Appendix O
Comment Response Tables

SSSTF 90% DRAFT FINAL DESIGN PACKAGE DOCUMENT REVIEW, COMMENT, RESOLUTION LIST - EPA

DOCUMENT TITLE: RD/RA Work Plan DOE/ID-10889				
Item	Section/ Figure/ Appendix	Page	Comment	Resolution
1	General	—	<p>No mention is made of the construction of the SSSTF within CPP-95 with the exception of discussion of AOC.</p> <p><u>Suggestion</u> It should be mentioned that the area has windblown Cs-137 contamination which is expected to be surficial and that the 95% UCL concentration of 5.9pCi/g does not represent an unacceptable industrial risk to workers or site visitors.</p>	The document was revised to state that the work to be performed, as part of construction of the SSSTF, will be conducted within the WAG 3 AOC – CPP-95. See Section 1.2, page 1-3.
2	Sect 1.2.1, 1st bullet	1-5	The description in the text of the EDF-1540-Waste Inventory Design Basis states that the anticipated waste streams are based on the CERCLA Waste Inventory Database Report for Operable Unit 3-13 Waste Disposal Complex (CWID). The CWID, however does not provide a comprehensive analytical assessment of the subject sites but a compilation of the available analytical data and/or proce

Figure 2-1 Process Flow for adding new waste streams to approved list for the ICDF Complex

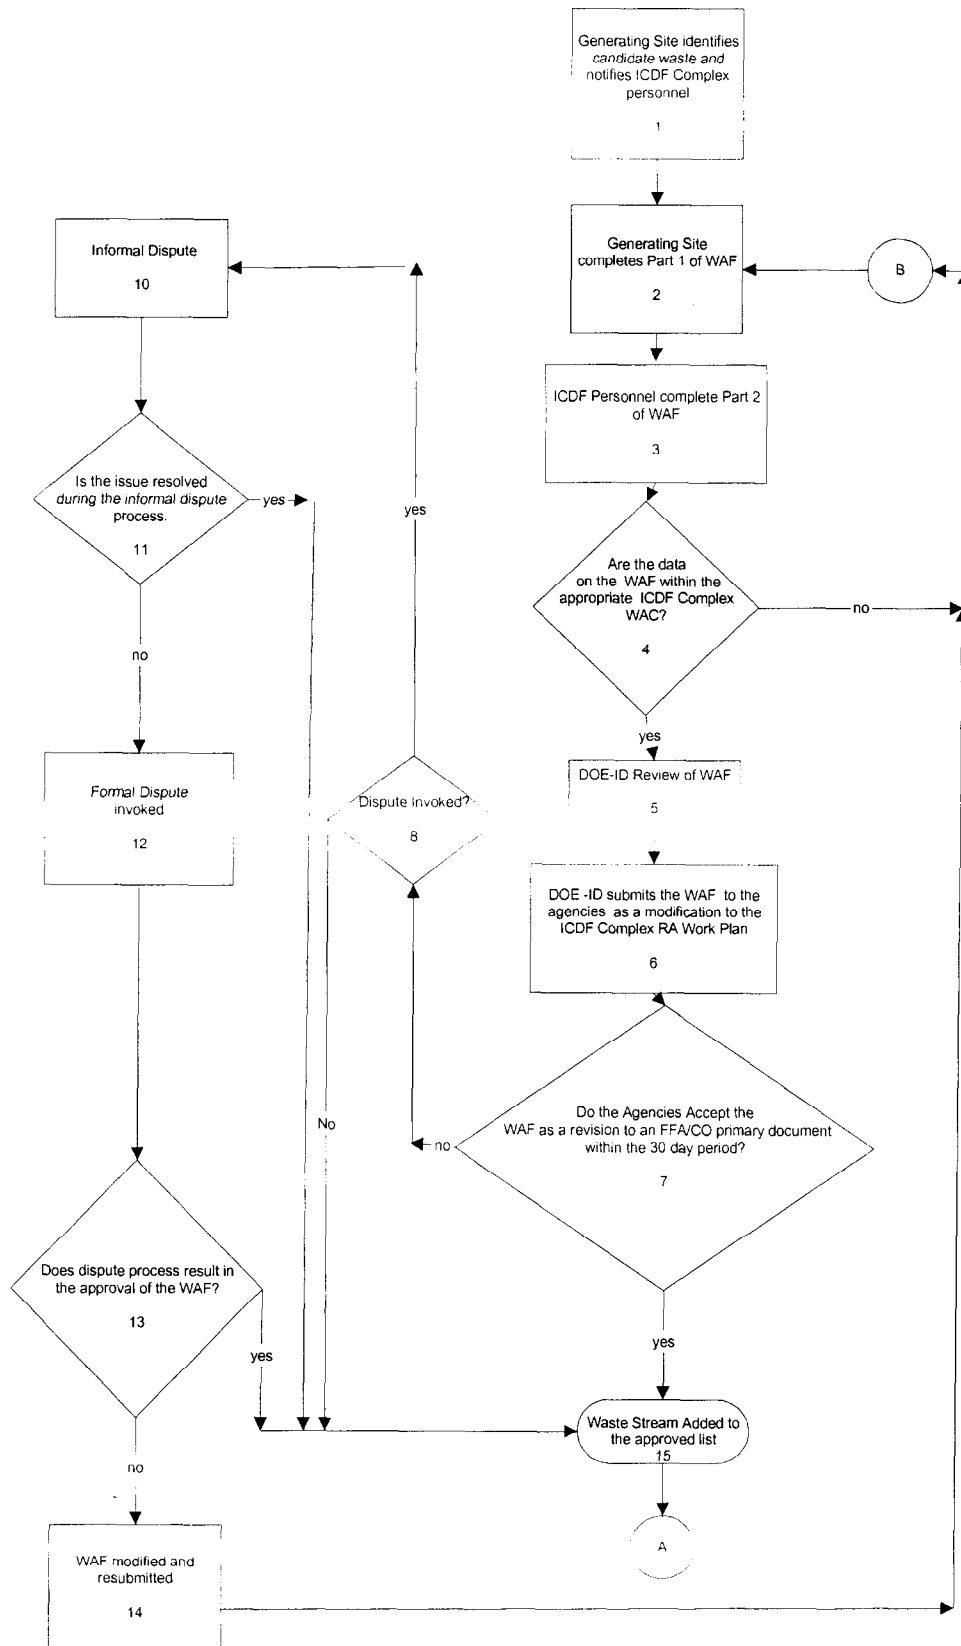
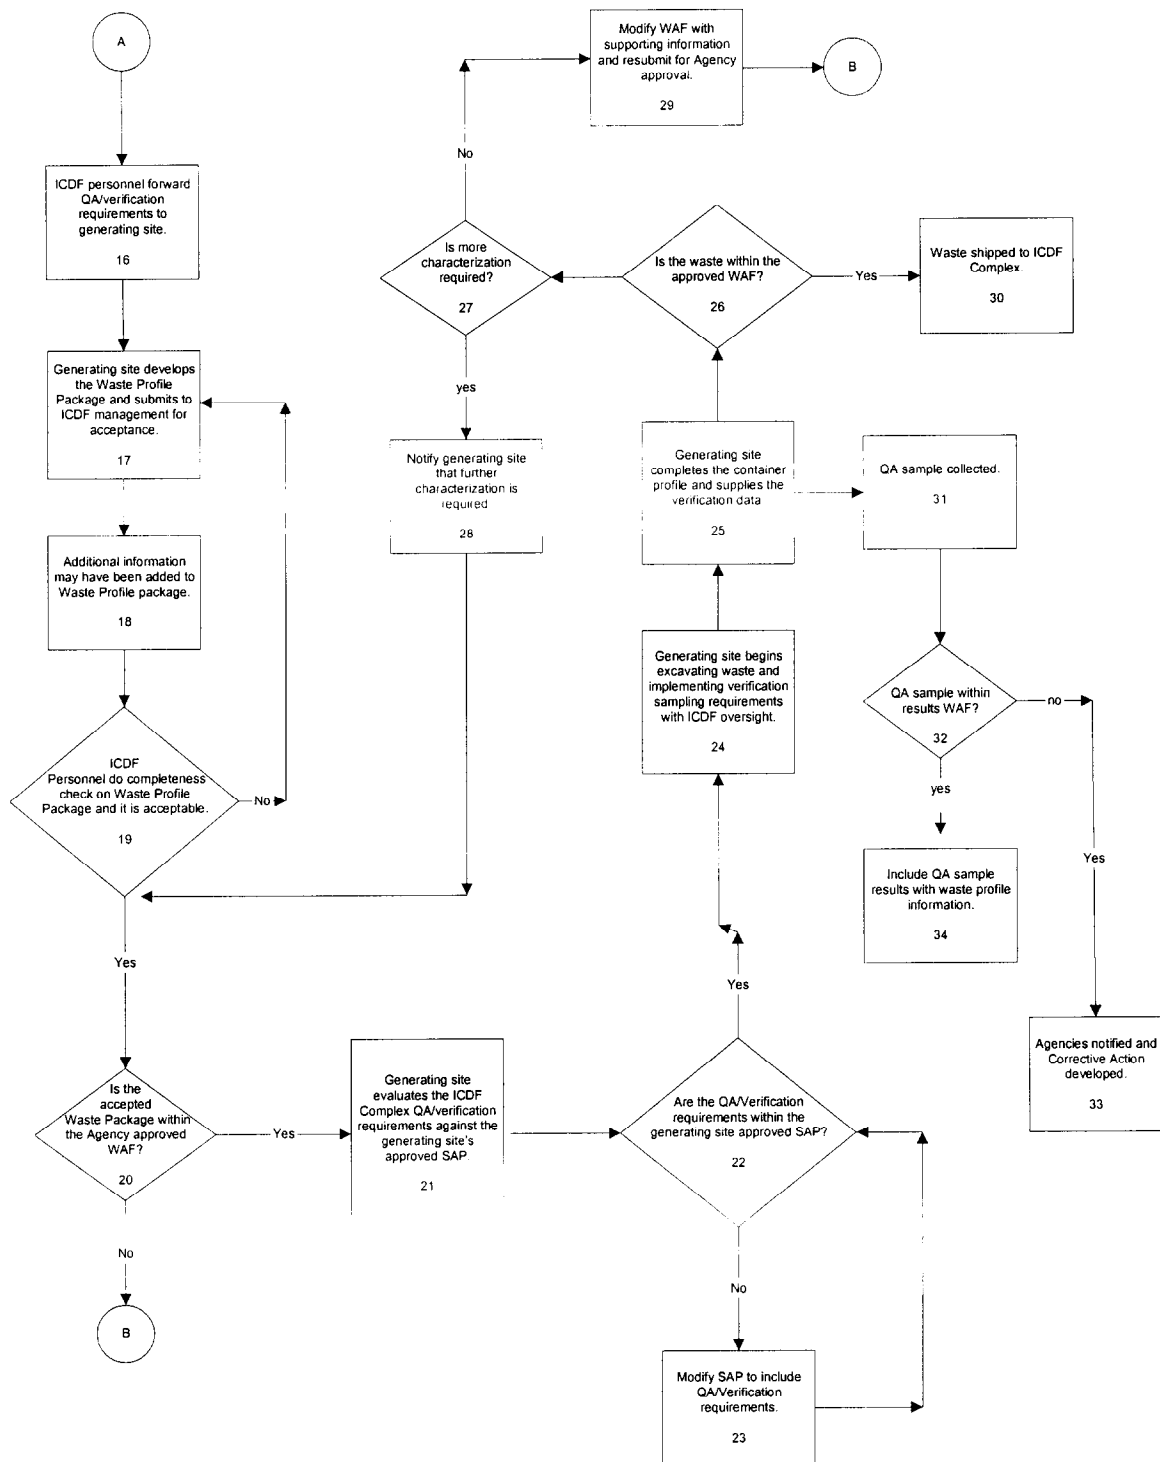
191.**	Figure 2-1	4	The primary document modification process is adequately described in the FFA/CO and this figure cannot preempt this process	DOE concurs that any modification to the RD/RA Work Plan will be in accordance with the FFA/CO.
